UNLESS OTHERWISE SPECIFIED DIMENSIONS ARE IN INCHES								LIGO CALIFORNIA INSTITUTE OF TECHNOLOGY MASSACHUSETTS INSTITUTE OF TECHNOLOGY			
TOLERANCES:		FINISHED SURFACE RMS 63						TITLE		Cap Mirror Clamp	
FRACTIONAL ± 1/32		BREAK CORNERS and EDGES						KEM		6/28/99	
THREE PLACE DECIMAL ± .005		ANGULARMACH ± BEND ±--						kmland		5/11/99	
TWO PLACE DECIMAL ± .01		REMOVE ALL BURRS						CAD FILE		D990118-B	
ANGULAR ± 1 deg.								SIZE		D990118-B	
MATERIAL:		HEAT TREAT:		FINISH:				DATE		SHEET	
S Stl Purchase Part		none		none							
McMaster 9230A240											
USED ON: XXX		NEXT ASS'Y: XXX									
REFERENCE DRAWINGS				ISSUE DESCRIPTION				SCALE		FULL

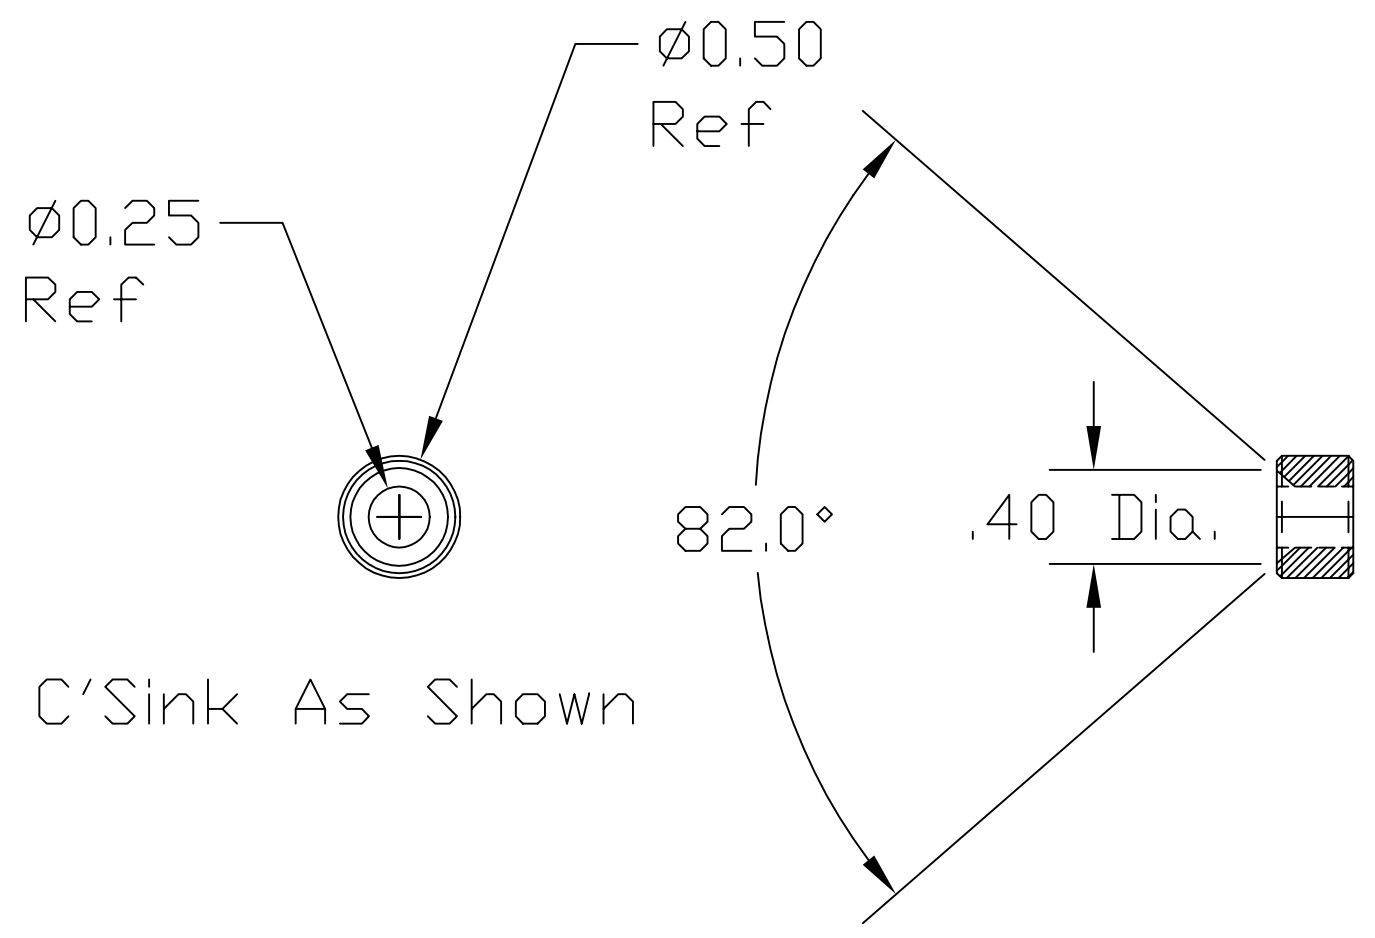
NOTES: (UNLESS OTHERWISE SPECIFIED)  
~~Liquid contaminants/Machining Lubricants~~  
 Liquids containing hydrocarbons or other contaminants, other than the machining fluids specified herein, shall not be allowed to come into contact with suspension material at any time. All machining fluids shall be water soluble and free of sulfur, chlorine and silicone; such as Cincinnati Milacron's Cimtech 410 (stainless steel).

Bag and Tag W/ Part No.

Modify: C'Sink As Shown

Qty. Make 3 Per Assembly
